## TECHNICAL SERVICE BULLETIN

### VSB-04: Correction of Grey Tank Drain

**TSB #:** VSB-04

**Models Involved:** 2021 Beacon 390LK and Vilano 41LKB Fifth Wheels built between October 15, 2020 and December 10, 2020.

REPAIRED TANK DRAIN

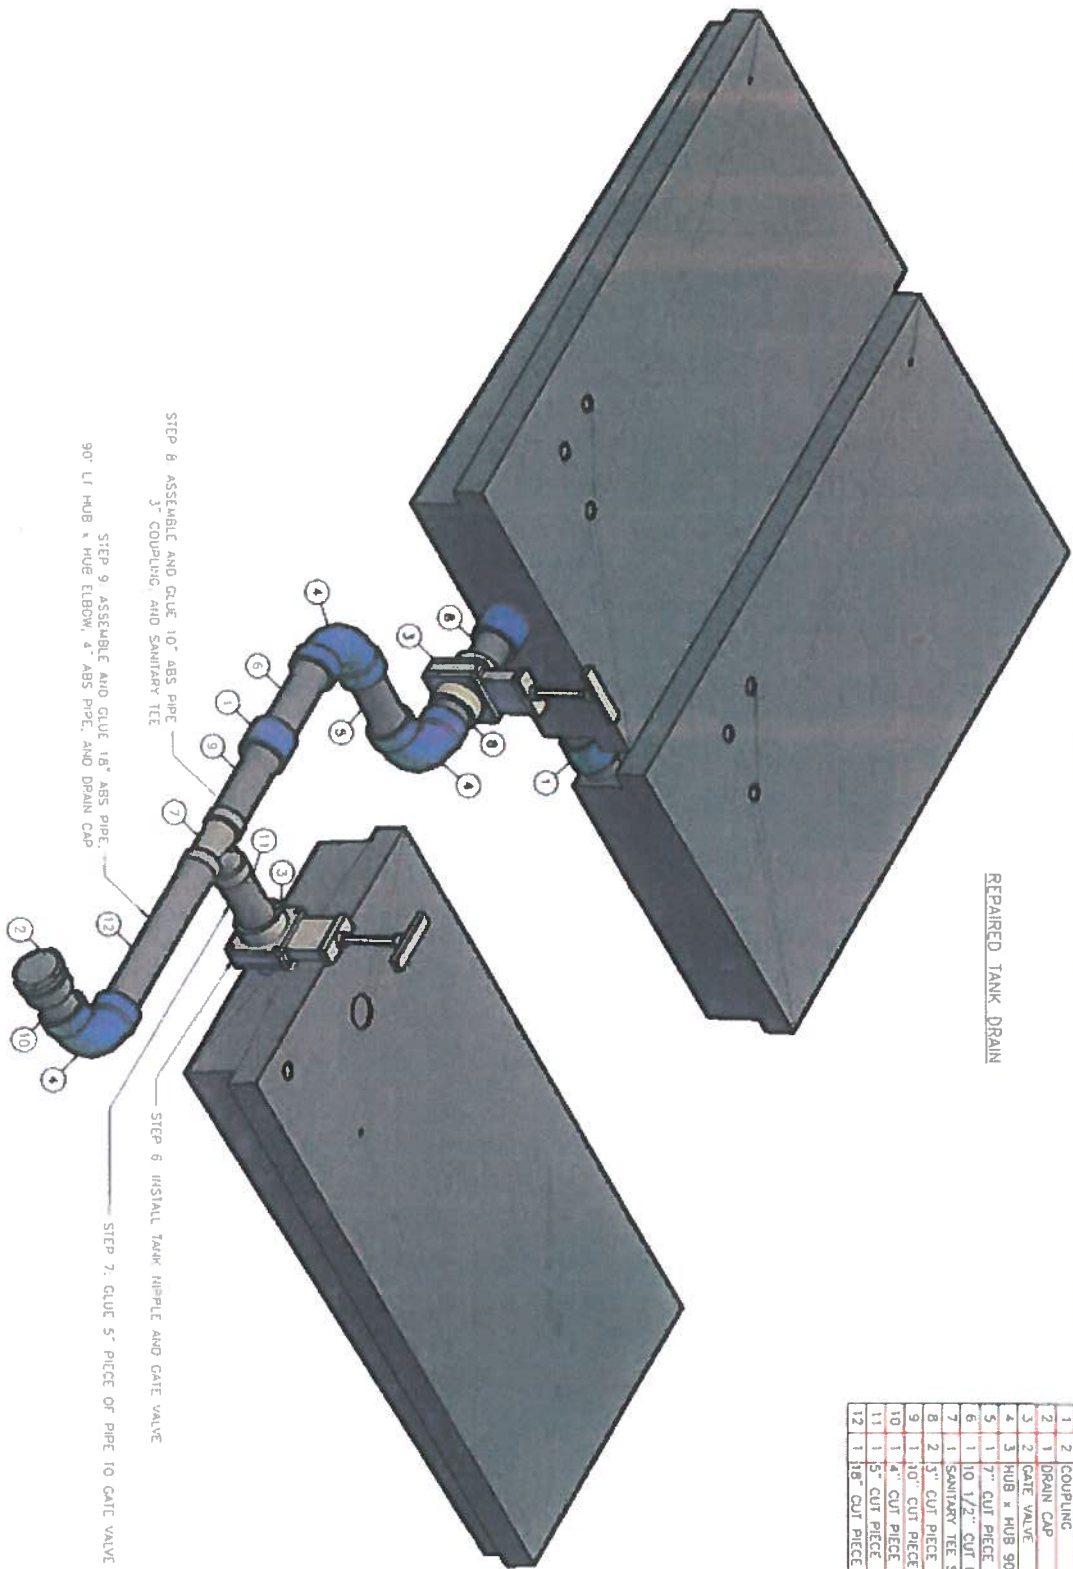
It has come to our attention that some 2021 Vilano and Beacon 5<sup>th</sup> wheel RV's were manufactured with the gate valves arranged in such a way that the black and the grey valves must be open to drain the gray tank.

REV	BY	DATE	DESCRIPTION
A	MBB	9/21/2021	REVISED TO ALLOW TANKS TO DRAIN INDEPENDENTLY

3. Cut the drain pipe coming from the gray tanks 10 ½" away from the 90° elbow.
4. Cut the pipe connecting the sanitary tee to the black tank. This will allow the technician to unscrew the gate valve from the black tank.

5. Remove the cut section from the black tank and disconnect the wires from the valve.
6. Screw in new ABS 3" pipe nipple on the black tank. Install the new gate valve at the front of the tank and connect the existing wires.

7. Add and glue a 5" piece of ABS black pipe to valve.
8. Add and glue a sanitary tee with a 10" piece on the gray tank side of the drain system. Glue the pipe coupling to the 10" piece of ABS pipe. Make sure the sanitary tee bend flows the correct direction, towards the drain.

9. Assemble the 18" piece of ABS pipe with the 90° elbow, the 4" piece of ABS pipe, and the drain cap.
10. Connect the assembly from step 7 to the sanitary tee.
